Re: Pocono Mountains Municipal Airport (MPO) Annual Safety Inspection

On October 25, 2018, an airport safety inspection and Airport Master Record (5010) update were conducted at the Schuylkill County Airport. This letter outlines the findings by our regional Aviation Safety Specialist, Mr. John Logan, and includes a copy of the updated Airport Master Record (Form 5010-1) for your review.

Pocono Mountains Rwy 13

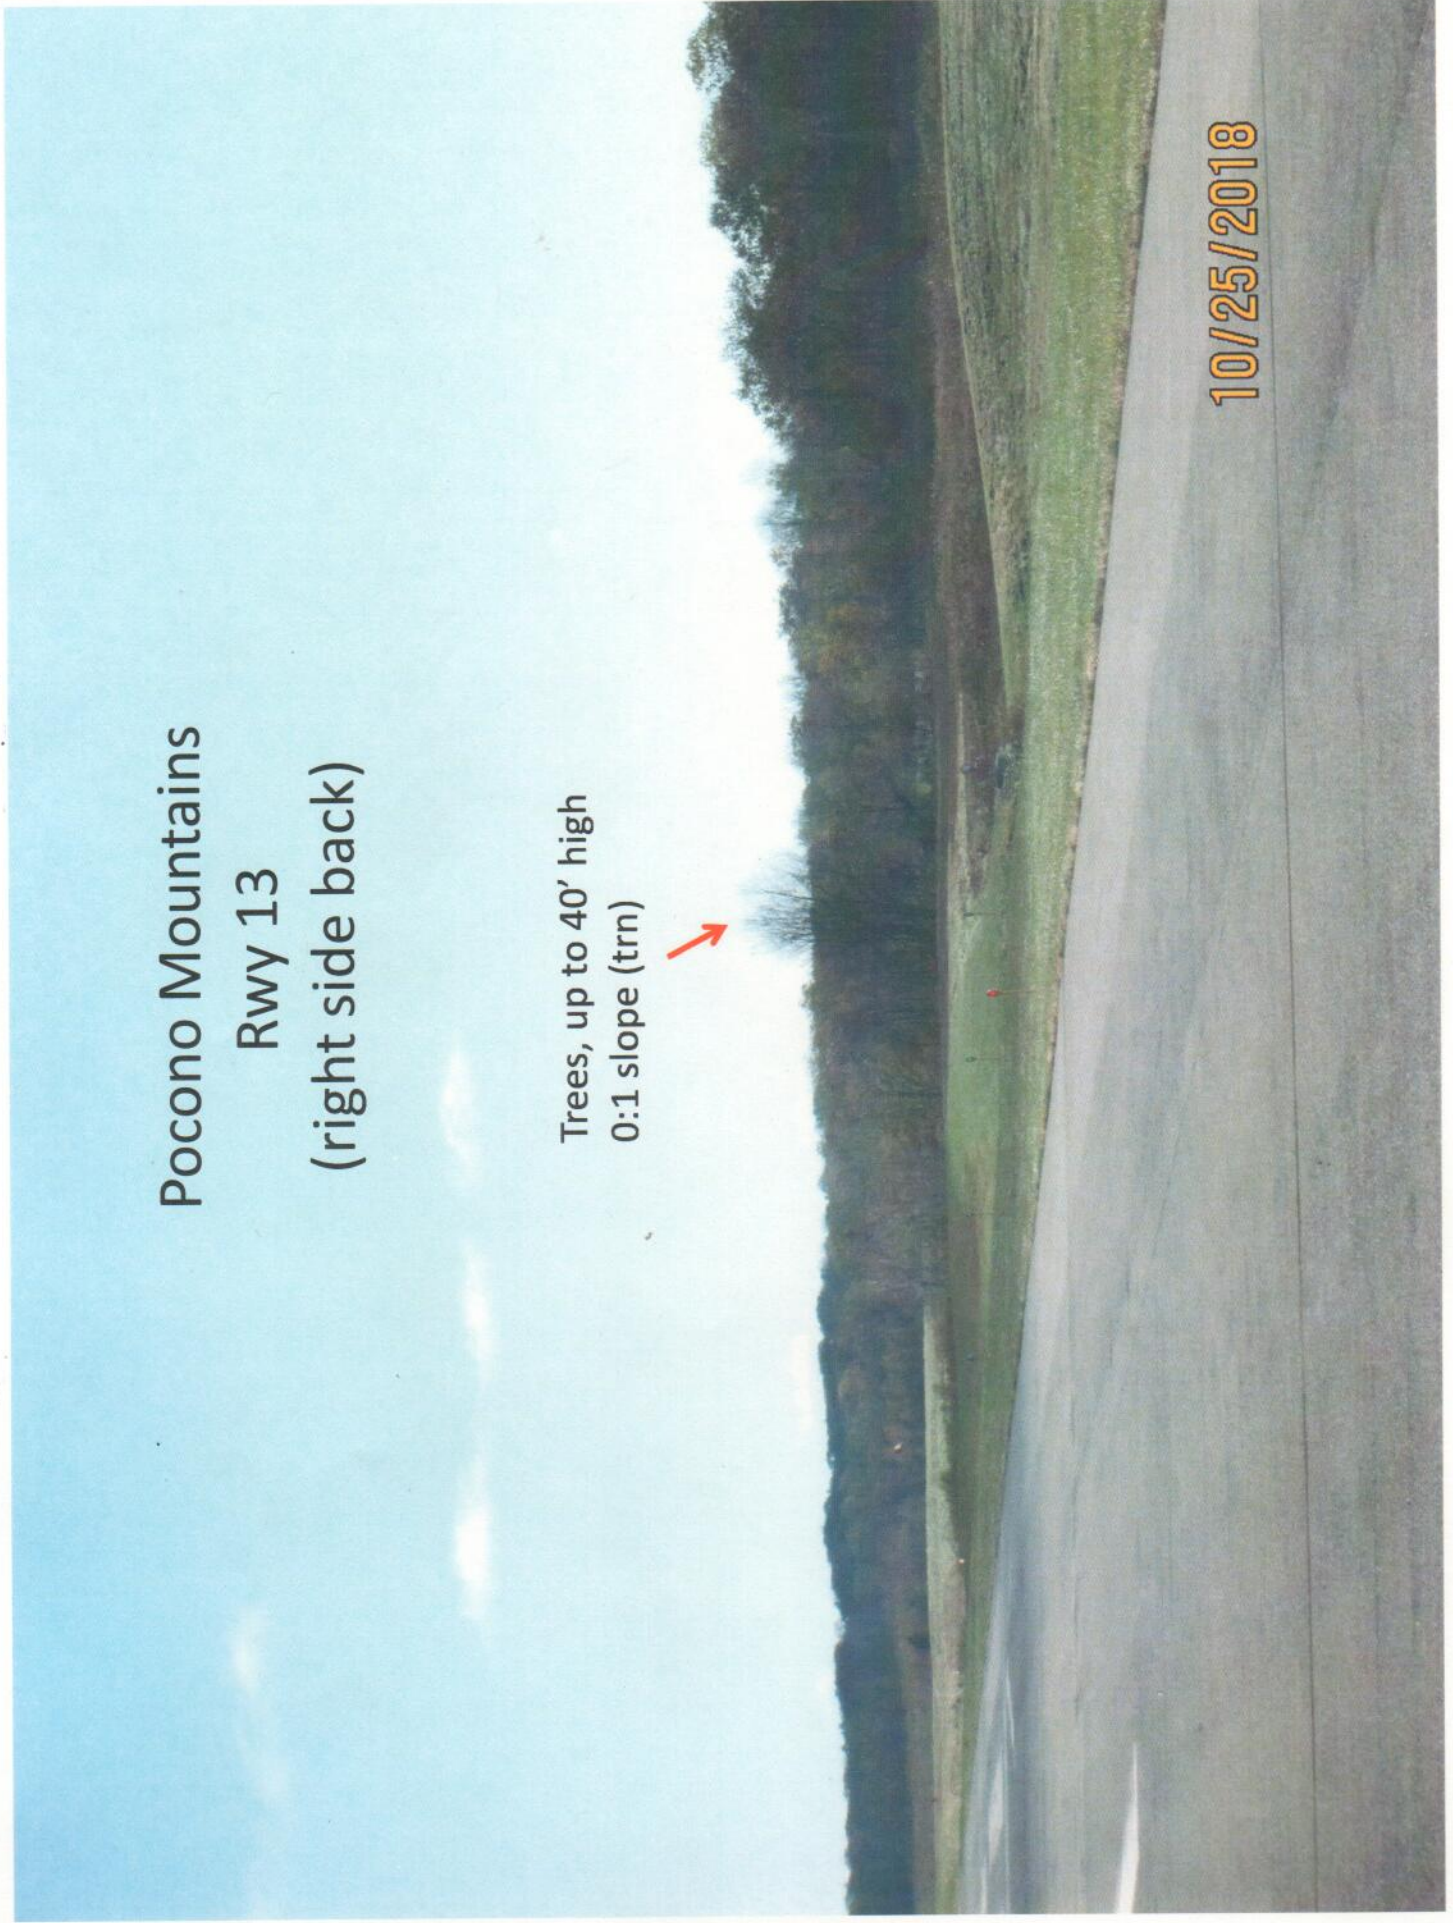
Trees, up to 46' high
2:1 slope (trn)

Trees, up to 40' high
9:1 slope (app)

Pine, 37' high
14:1 slope (app)

Close Trees, 23' high
20:1 slope (app)

Trees, up to 52' high
20:1 slope (app)
